YEAR 4 MONITORING REPORT

UT MILLERS CREEK

DMS Project ID No. 95719, Contract No. 5000, USACE Action ID No. SAW-2013-00386

Re: NCDEQ – Division of Mitigation Services
UT Millers MY 4 Monitoring Report
UT to Millers Creek Draft Year 4 Monitoring Report
Cape Fear River Basin, CU 03030006, Duplin County, DMS Project No. 95719

Figure 6.8 Wetland Gauge 6

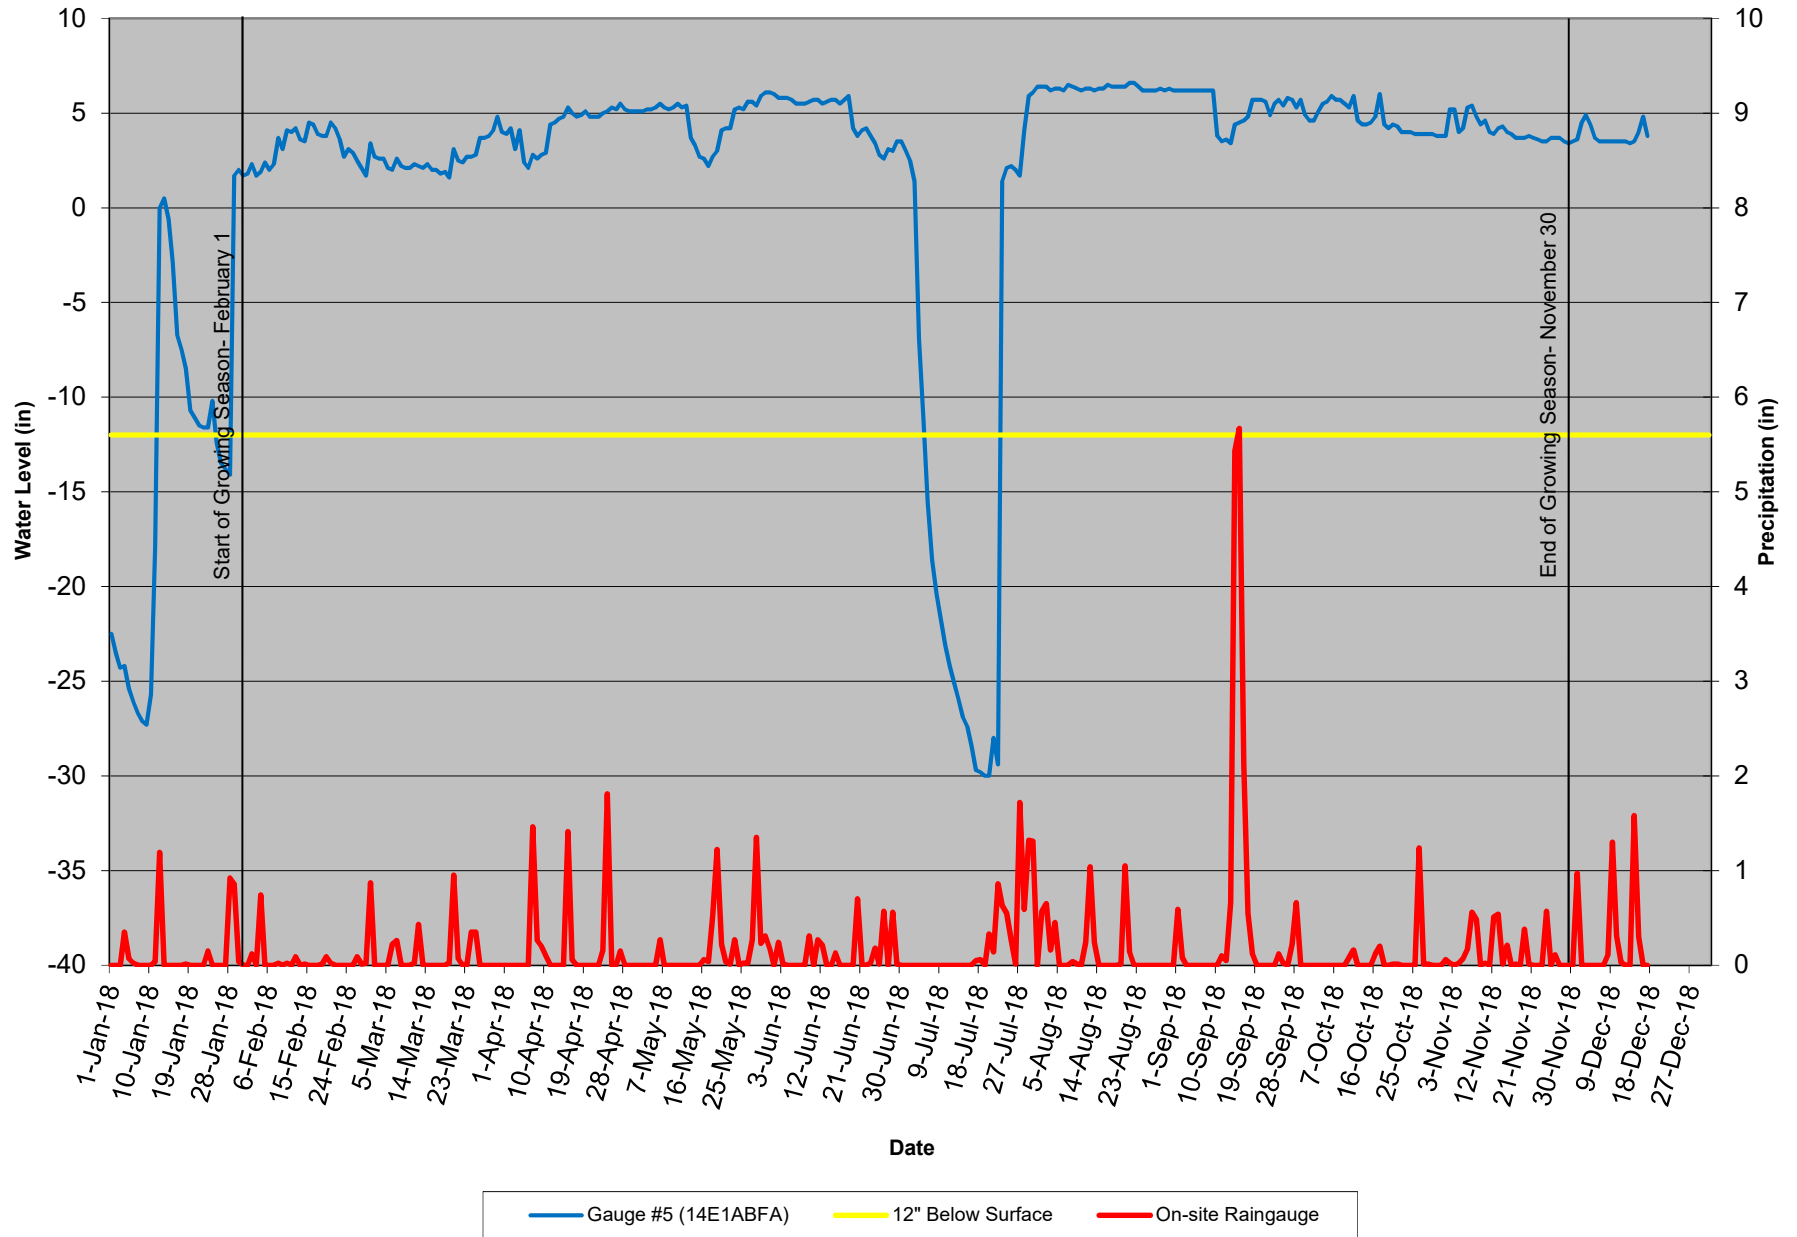
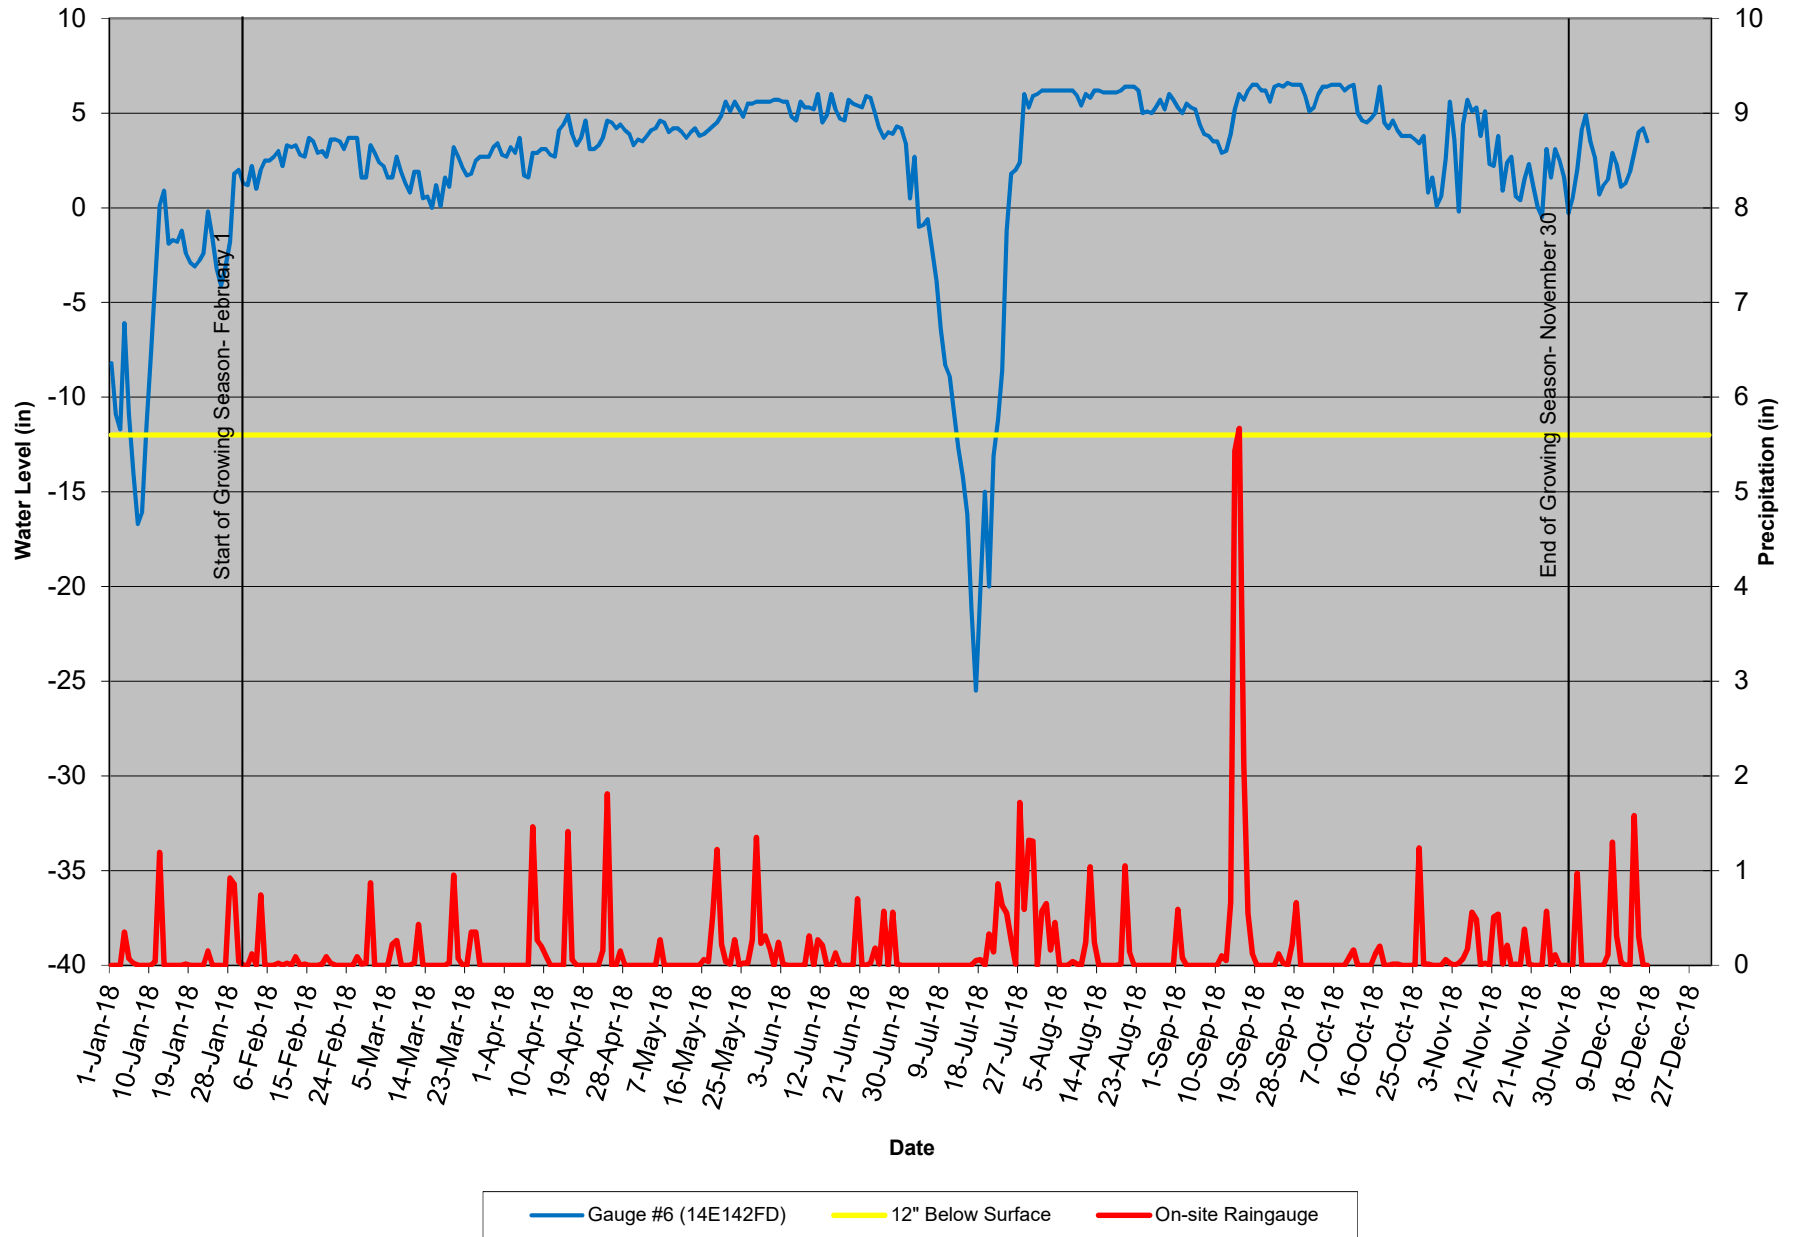
1. *Update hydrographs and Table 8 with data through the growing season (at least through 11/11). It is possible that the two gauges not meeting may achieve success during this time.*

The hydrographs have been updated through the entire year. All of the gauge locations are meeting success criteria.
